Re: **Scoping and Environmental Review Process for the Rosemont Copper Project**

Re: Scoping and Cooperator Status for the Rosemont Copper Project EIS

Re: Rosemont Mine Plan of Operations July 11, 2007 - Review for Completeness

RE: PDEQ Comments on Augusta Resource Corporation's Rosemont Project Mine Plan of Operations

Figure 1) Location of Other Deposits at RP same as Figure 6-2 in 2007 Mineral Resource Update.

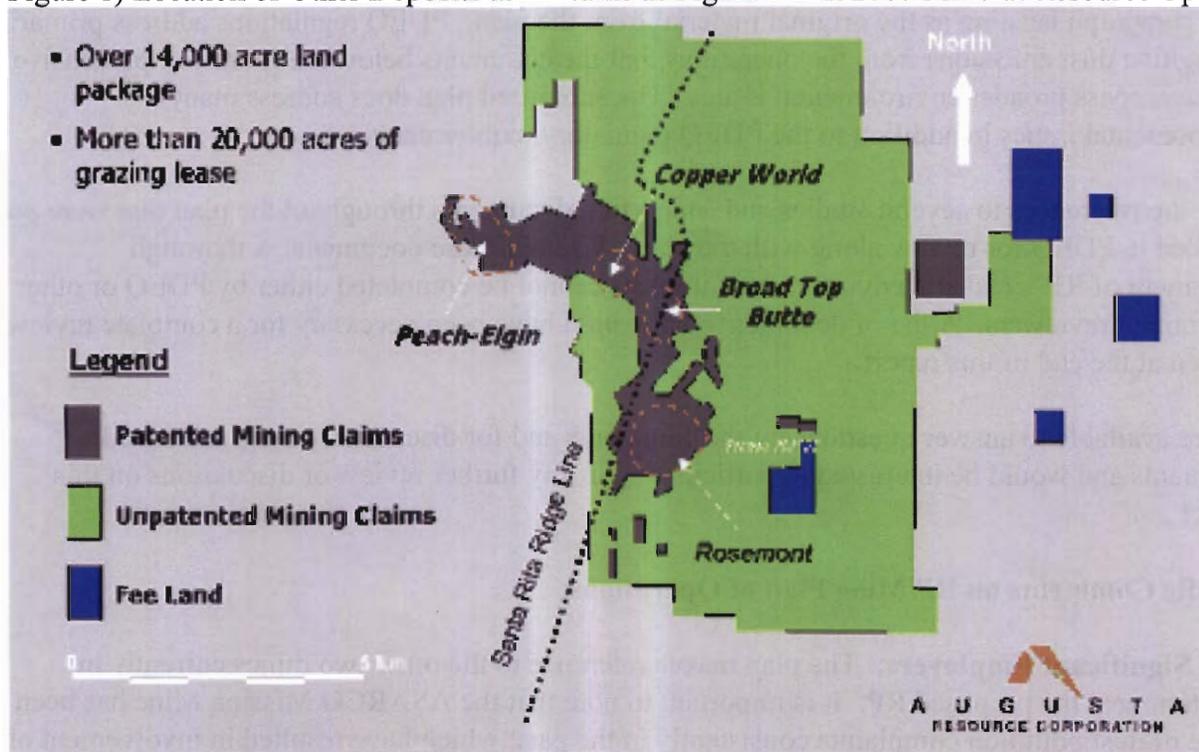
2.1.1 Open Pit Plans: The RP open pit configuration is stated to ultimately be "about 6,500 ft across north to south, 6,000 ft across east to west, and will be about 1,800 to 2,900 ft deep." It is understood exact pit configuration cannot be determined now due to the fluctuation in metal prices and precise information on the distribution of mineral reserves. However, PDEQ would like to see some limitations on pit size included in the document so that a guarantee is given on the allowable extent of the pit.

Review of the 2007 Mineral Resource Update for the Rosemont Project, dated April 26, 2007, revealed the presence of a total of 4 deposits on the Rosemont Property. They included the Rosemont Deposit, which ARC has planned to extract, the Broadtop Butte Deposit to the north of Rosemont, the Copper World Mine to the north and west, and the Peach-Elgin Deposit to the north and west. All three of the other deposits lie partially or completely over the ridgeline of the Santa Rita Mountains (see Figure 1 below.) Development of these potential resources in the future would lead to visual and physical impacts not addressed in the plan. In order to consider this version of the plan complete, PDEQ would need some statement incorporated that these deposits specifically will *NOT* be developed in the future, regardless of economic incentive. Incorporation of such intentions in the closure planning of the mine will be necessary to prevent sale of the other deposits to mining interests in the future. The recent complaint filed by ASARCO contesting ARC's ownership of the mine testifies to other firms' interest in the Santa Rita Range (<http://biz.yahoo.com/iw/070824/0294999.html>).
